SERVICE BULLETIN

Subject: Pinsetter Sweep Switch

Date: 3/10/06

Bulletin No. SB06-2

INCORRECT ASSEMBLY
Figure 1

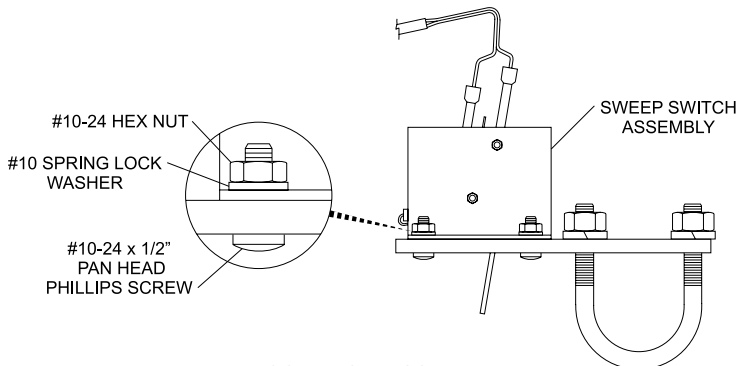
It has come to our attention that some of the Sweep Switch assemblies, package number 57-863172-000, have been assembled incorrectly. The two screws that mount the switch plate are the incorrect size and the lock washers were incorrectly placed under the screw head and are the incorrect type to assemble the switch plate to the sweep switch assembly. Refer to *Figure 1, Incorrect Assembly*.

The correct assembly is shown in *Figure 2*. Use a #10-24 x 1/2" pan head Philips screw, part number 11-012328-001, #10 spring lock washer, part number 11-195010-001, and #10-24 hex nut, part number 11-125004-001. These parts can be purchased from a local hardware store or can ship directly to the bowling center from Scott Anderson, 800-944-0325 (USA), 616-379-0325 (International), email – sanderson@northcc.com.
